Determination 2019/023

Regarding the compliance of a proposed glass balustrade with Building Code Clause F4 Safety from falling at 540 Albert Street, Palmerston North

Summary

Figure 1: The proposed barrier design (not to scale)

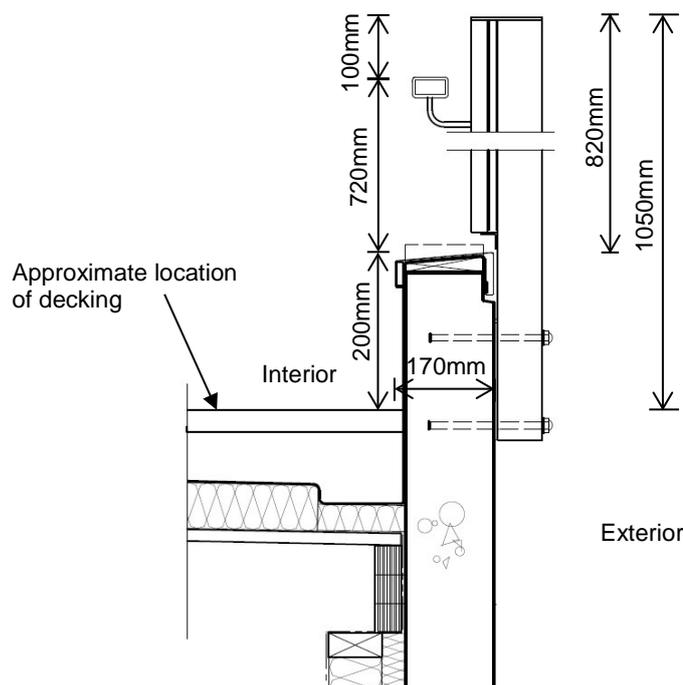
- 4.2.6 In this case the proposed barrier design has glass panels attached to the outside of the concrete panels. This is comparable to the nib and glass construction in Figure 3 above. However, the width at the top of the nib, including the flashing capping to the panels, at 170mm is considerably wider than 15mm allowed for in Figure 3. Alternatively, Figure 3 provides for this nib to be wider than 15mm if it incorporates a 60° fillet, which in this case has not been included in the proposed barrier design.

- 4.2.7 The proposed barrier design also incorporates a handrail, with the top of the handrail being 100mm below the top of the glass panels. The F4/AS1 construction shown in Figure 3 does not have any projections from the glass sections of the barrier, with a handrail instead located on top of the barrier.

- 4.3.3 The proposed design has a 170mm wide nib (including the flashing). This is wide enough that it can be stood on by a young child, taking into consideration Figure 3 restricts the size of a nib to 15mm. I have considered whether any of the constructions shown in F4/AS1 include a similar climbable feature and how it is mitigated. The two following examples from F4/AS1 contain features that would act as a ledge or step for a young child to climb and stand upon.

- 4.3.9 However, as mentioned in paragraph 4.2.7, the proposed design also incorporates a handrail. The top of the handrail is 100mm below the top of the glass panels, and it projects out from the glass panels. The top of the handrail is 720mm above the nib and flashing.

- 4.3.10 The handrail projects out from the glass panels, which a young child could use to pull themselves up and scale the barrier. Using the heights from F4/AS1 as guidance, at 720mm the handrail would be easily reachable by a young child standing on the ledge created by the nib and flashing. This handrail in combination with the 170mm climbable ledge negates the fact that solid glass panels are proposed. I consider that the proposed barrier design would therefore be easier for young children to climb than constructions shown in F4/AS1.

4.3.12 Accordingly, I am of the view that the height of the glass panels is appropriate taking into account the nib. However, due to the presence and location of the handrail the proposed design does not comply with Clause F4.3.4(g).

5.1 In accordance with section 188 of the Building Act 2004, I hereby determine that the proposed design of the glass balustrade does not comply with Clause F4.3.4(g) of the Building Code.

Figure 2: Revised handrail dimension

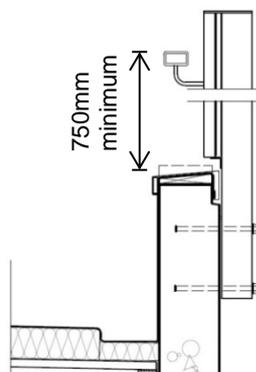
3.5 On 26 April 2019 the architect responded accepting the determination, and noted the consented drawings contained a mistake in regard to the balustrade height. The handrail should have been dimensioned from the top of the nib, as below.

3.6 I note the altered design with the top of the handrail within 750mm of the nib does not meet the minimum height requirements identified in F4/AS1 (refer paragraph 4.3.8). For the reasons discussed below, the decision in the determination would remain unchanged because the altered design does not comply.
